SERVICE INFORMATION

BRIVILOR BONAMAT

NO : 6.
TITLE : brewerchamber
MODEL : All FreshMore and Freshground dispensers
DATE : 07-09-2010

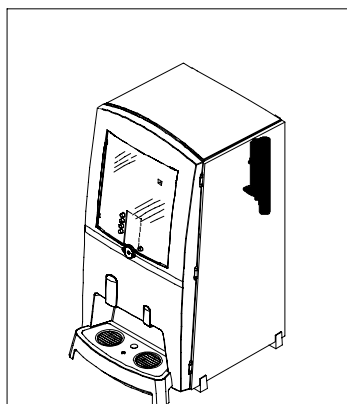
Changes within the Brewer and therefor new article numbers.

The old brewerchamber is replaced by an detachable brewerchamber, which will make the cleaning easier.

- 6.030.061.130 Spring brewerchamber
- 6.030.061.131 Pressurespring Unibrewer
- 6.030.061.132 Springpin removeble brewerchamber
- 6.030.061.133 Removable brewerchamber with pin
- 6.000.231.111 Exchange set
